**TOWN OF MOUNTAIN VILLAGE
REGULAR DESIGN REVIEW BOARD MEETING
AGENDA**

THURSDAY DECEMBER 3, 2020 10:00 AM

4.	10:10	60	Ward Applicant	Quasi-Judicial	Consideration of a Design Review: Initial Architecture Review for a new single-family residence on Lots 517 & 518 (518R) 146 Russell Drive, pursuant to CDC Section 17.4.11

1 EAST ELEVATION - ROOF HEIGHT ANALYSIS
1/8" = 1'-0"

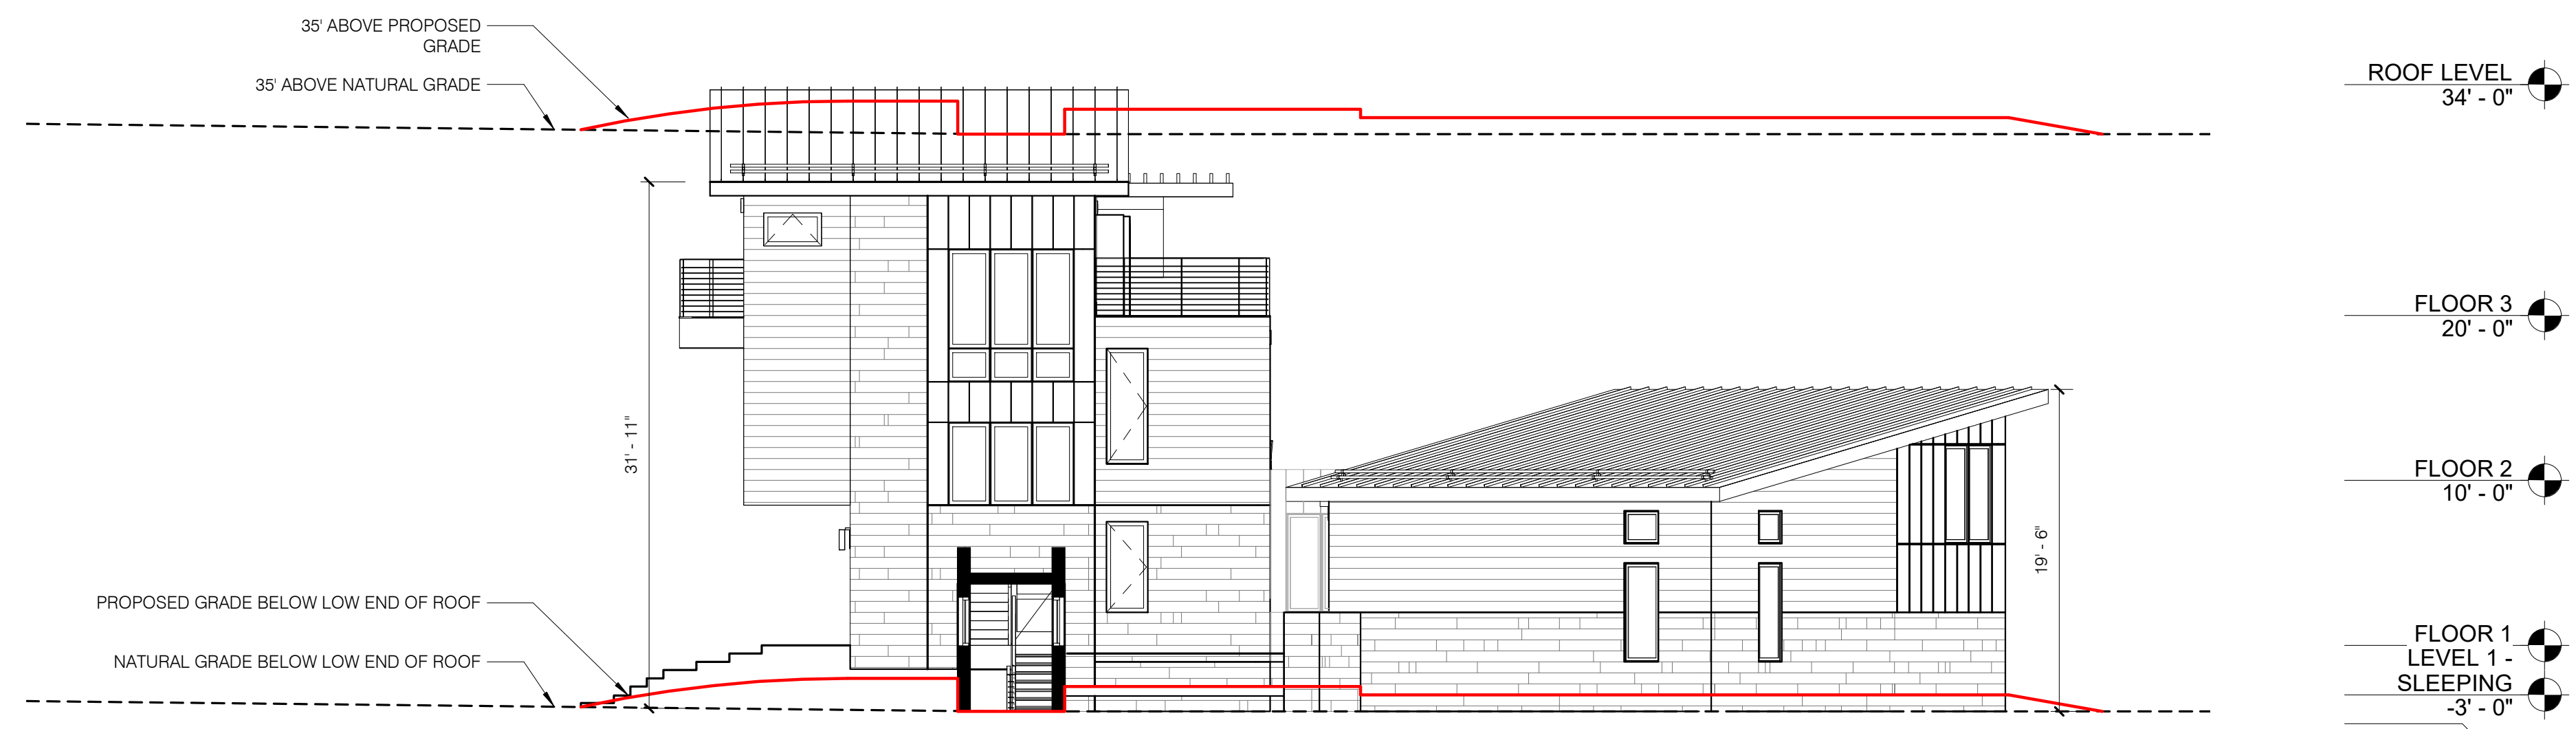
Staff: As part of this application, the applicant has provided both a Maximum Building Height and Average Building Height analysis. Based on the heights provided, the applicant is 34'3" feet from the highest ridge to the grade below in the tallest "pod" of the home. The other "pods" are significantly lower than this. Staff finds that given the data provided, it appears that the home meets both the height requirements for Maximum Heights and Average Max Height, but this should be demonstrated with a parallel plane study for final review.

Grading
and
Drainage
Plan

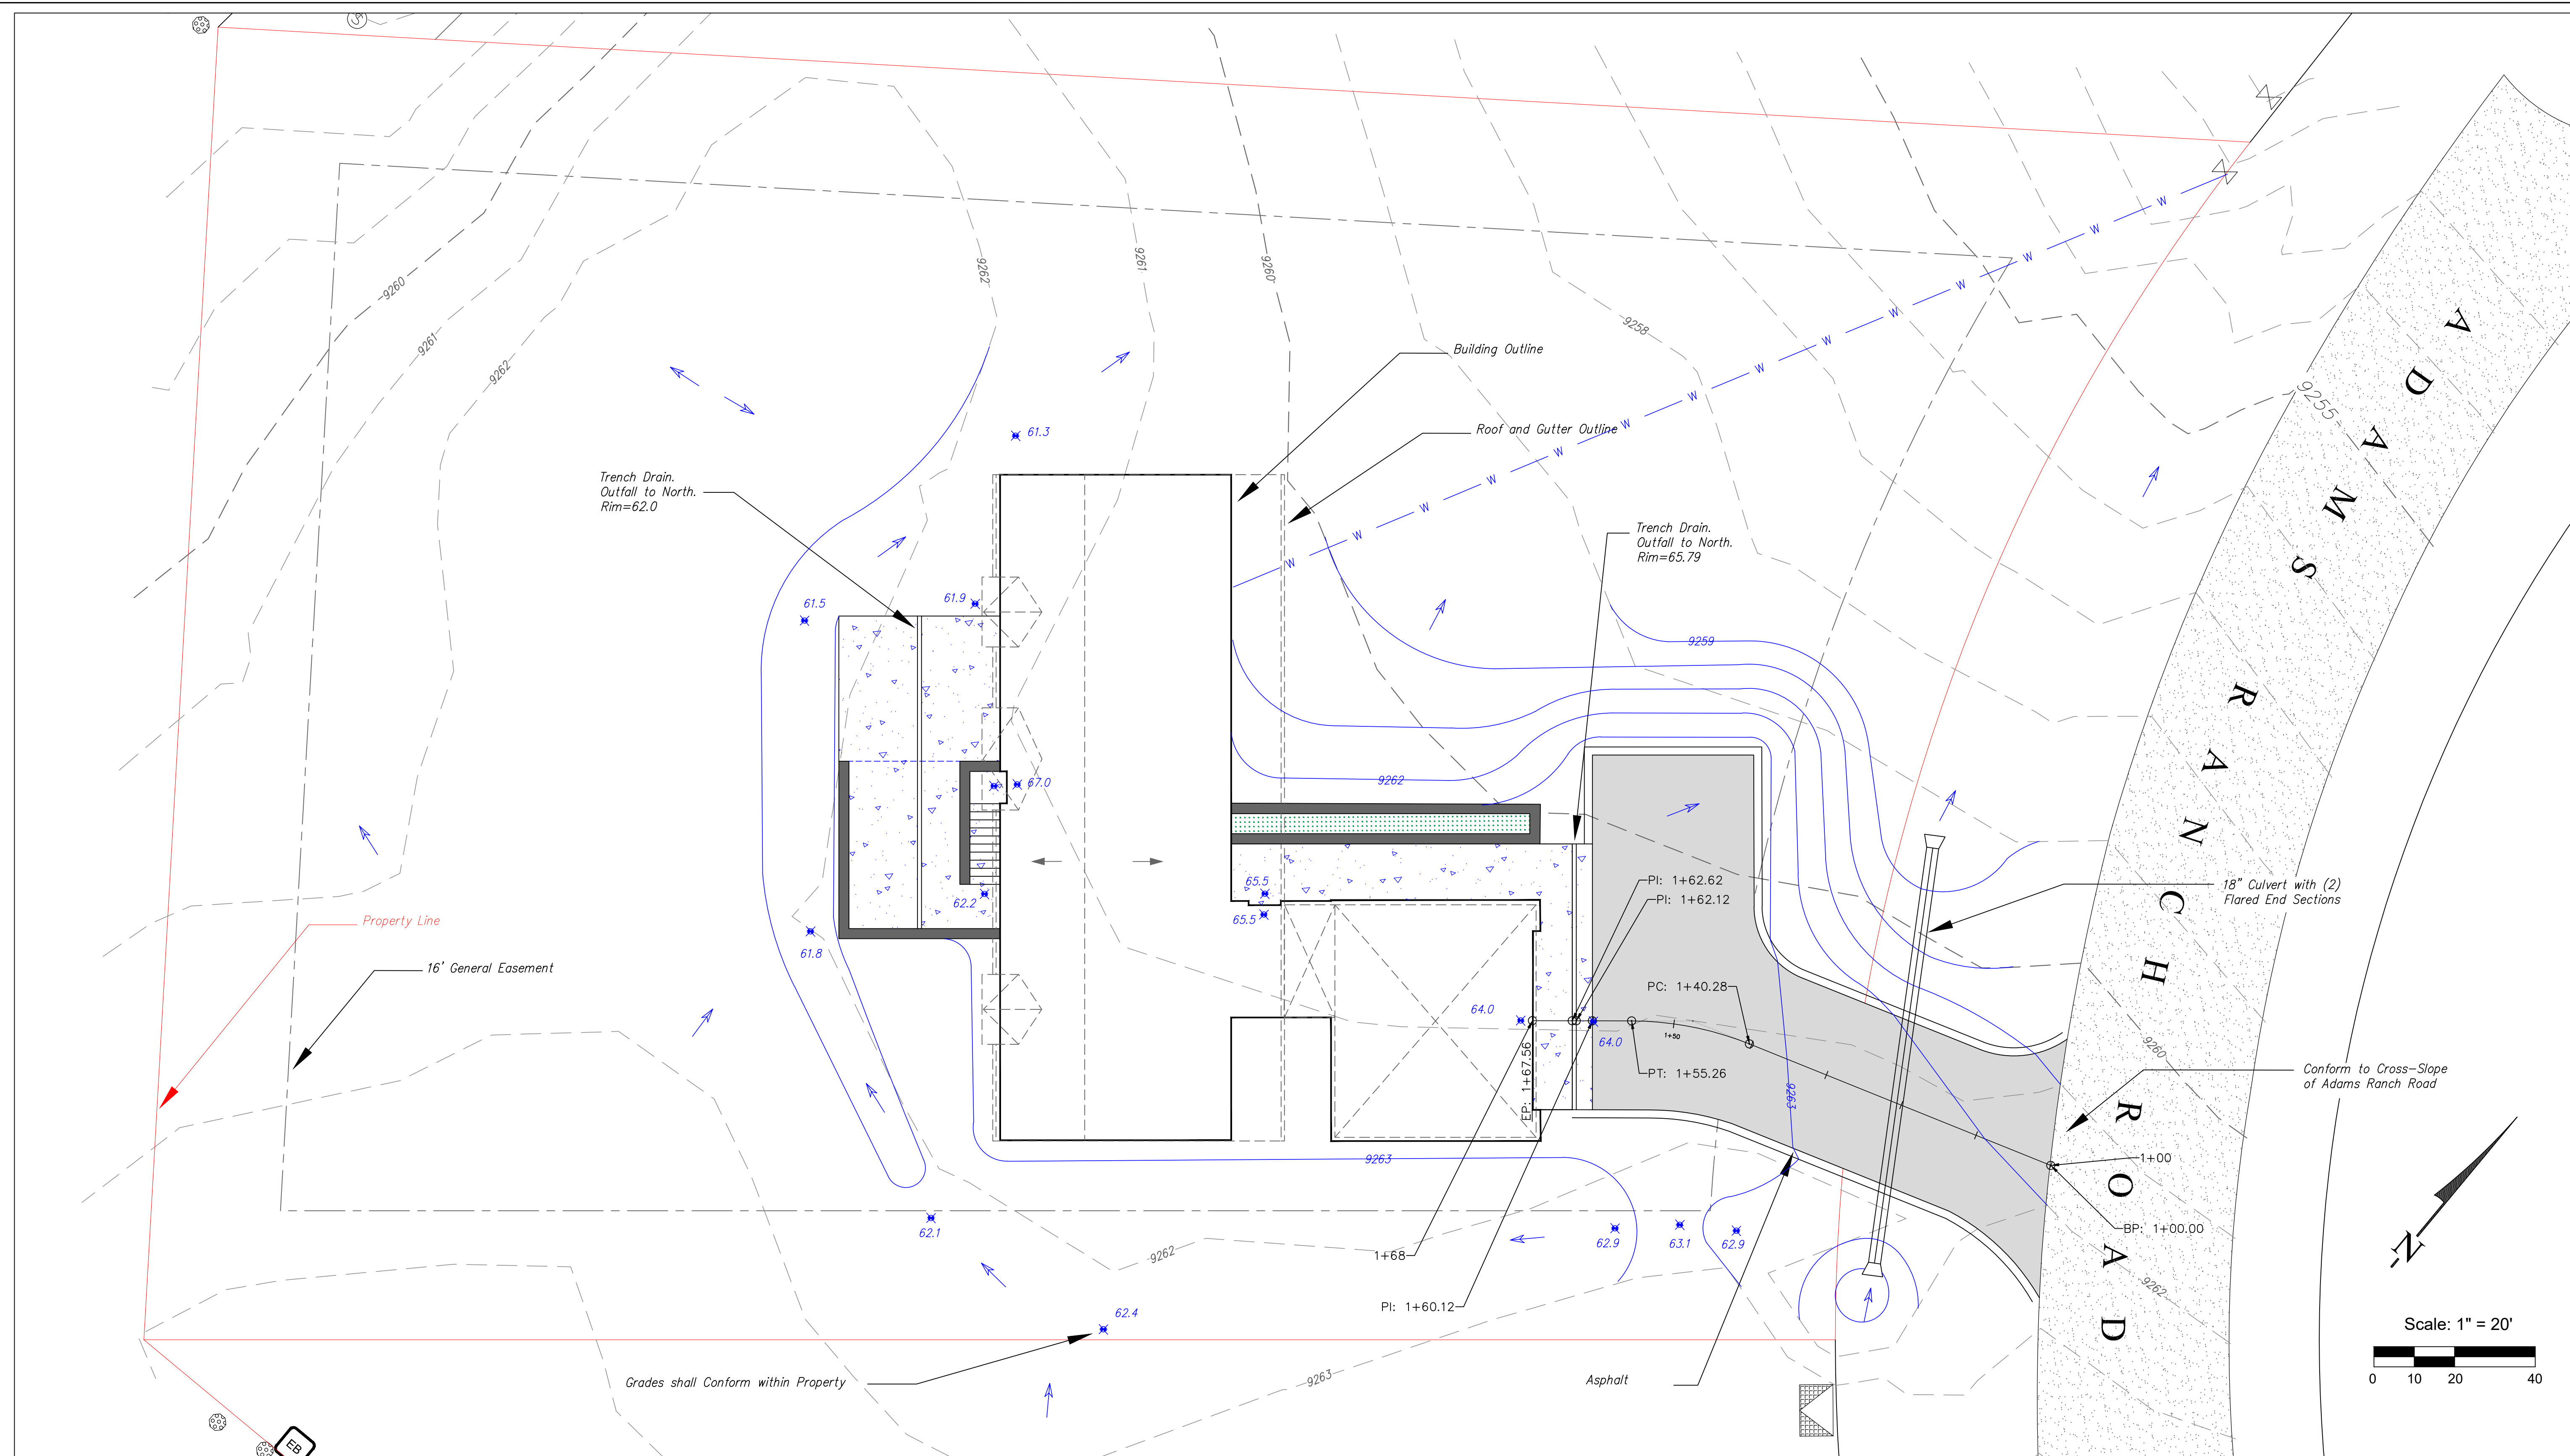
Staff: The lot has a mellow slope to it so should drain well naturally. The bulk of any proposed change in grade comes from the driveway cut. They have proposed no slope greater than 3:1, and do not propose any retainage along the driveway or parking areas. The driveway length is just at 150', anything over that would need to be wider than the 14' indicated, however the fire chief has reviewed it and says it is sufficient. They do show retaining walls along the south patio and the NW patio. It is unclear whether these are showing on included elevations, and more detail should be provided regarding their heights prior to the final architectural review. There is one man-made berm proposed near the NW corner of the property that doesn't extend into the GE, it appears to be appropriately contoured and shaped so that it will blend in with the natural landscape.

C3

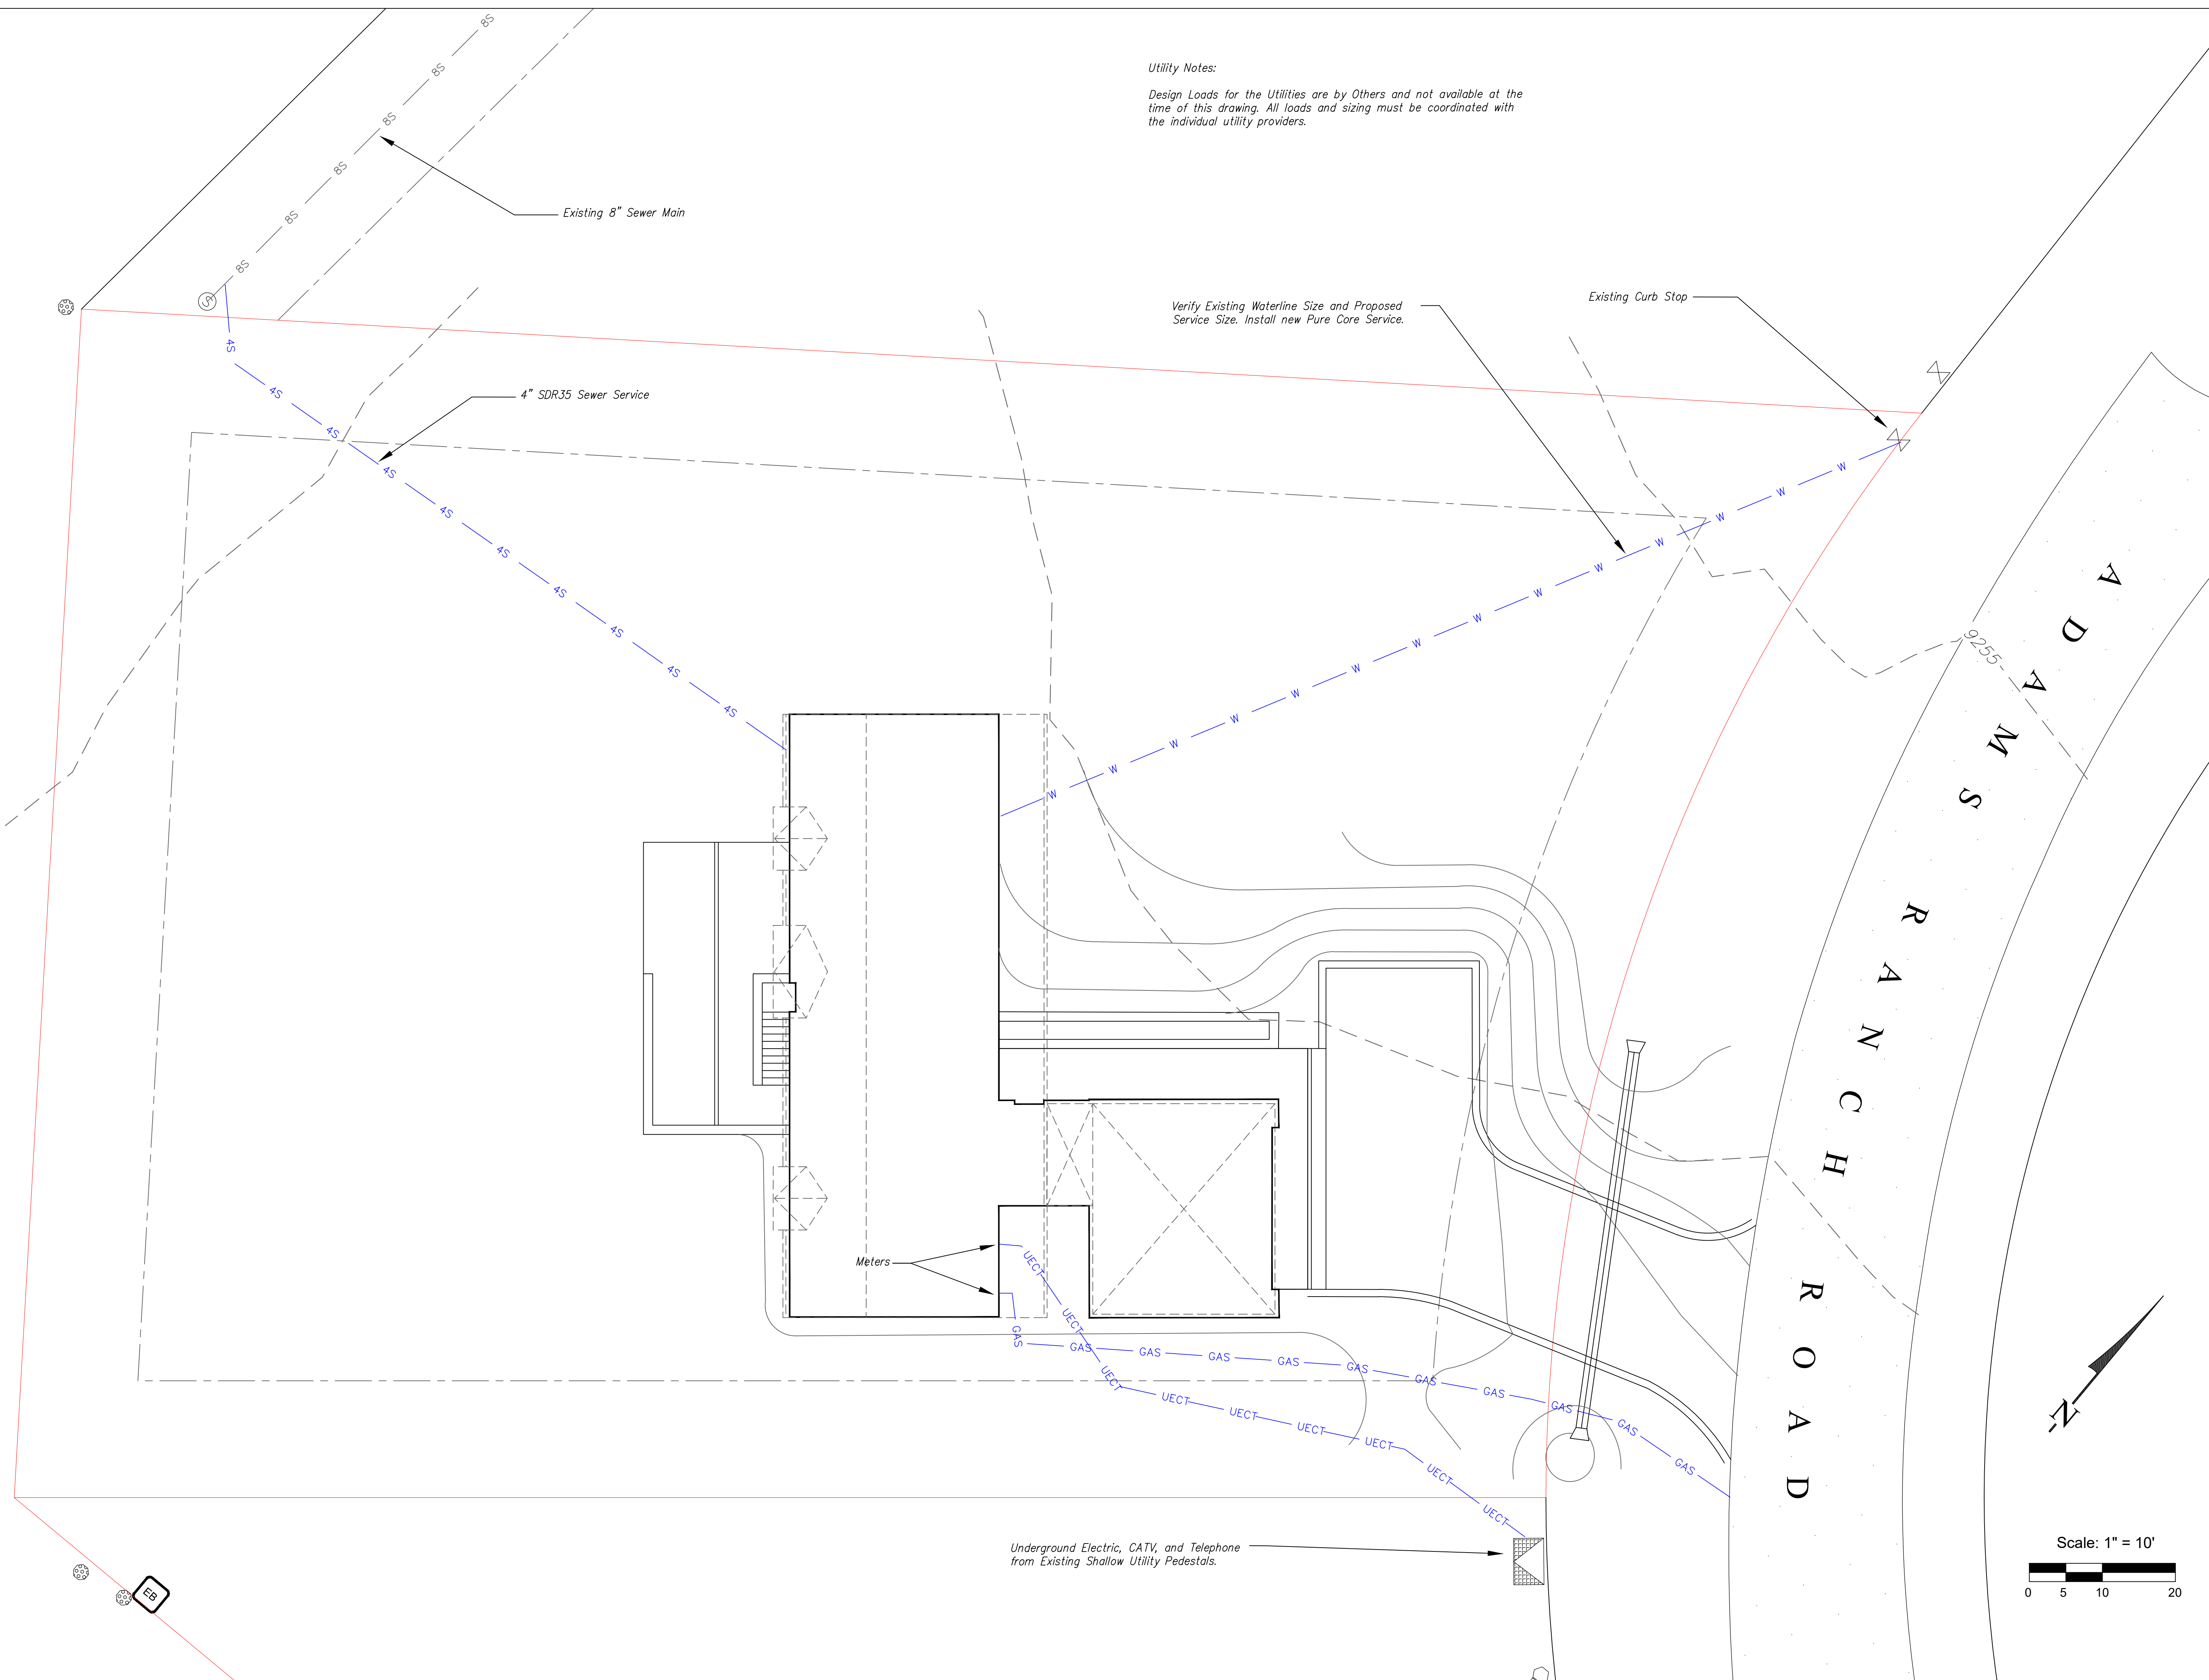
Staff: All utilities are currently located within the Russell Drive roadway and will only require connections from the road to the home. The applicant shall work with the Public Works Director before the final review to determine the specific locations of the connections for the home. The plan set shows the proposed connections and the locations of the proposed utilities based on field research.

- 3) Prior to the issuance of a building permit, the applicant shall field verify all utilities and submit a revised utility plan to the public works director identifying the location of utilities and connection points.
